SERVICE BULLETIN

FW8000 / FW8010 Series

Fifth Wheel Identification and Selection of Correct Rebuild Kits

May 6th 2001

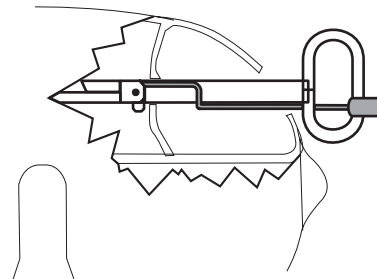
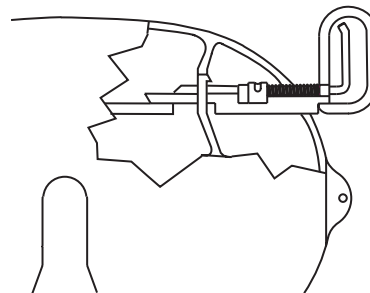
In March 2000 the operating mechanism of the FW8000 Fleetmaster fifth wheel was updated with a number of improvements to enhance the performance of the fifth wheel. The updated version of the FW8000 was initially known as a Generation III Fleetmaster to distinguish it from the earlier Generation II version but was later given a new part number and became the FW8010. A summary of Fleetmaster fifth wheel types and Generations is given in the table below.

The internal components of the Generation II and III versions of this fifth wheel are not compatible. Therefore it is essential that the Generation of the fifth wheel is clearly identified when ordering rebuild kits for FW8000 or FW8010 Fleetmaster fifth wheels. Identification of Gen. II or Gen III is easily achieved by the type of operating handle fitted to the fifth wheel as shown in the illustration below.

Handle with external push button for release of secondary lock

Handle with internal trigger grip for release of secondary lock

- RS-91078 : Jaw kit for Generation II fifth wheel - no longer available, use RS-91097 full overhaul kit
- RS-91097 : Full overhaul kit, suitable for Gen. II and Gen. III. Contains all parts necessary to rebuild a Gen. II fifth wheel to Gen. III specification
- RS-91099 : Jaw kit for Generation III fifth wheel - Must not be used in a Gen. II fifth wheel

Under no circumstances should Gen. II and Gen. III parts be interchanged, they are not compatible and may cause your fifth wheel to malfunction. Always use full repair kits and utilise all parts when rebuilding fifth wheels
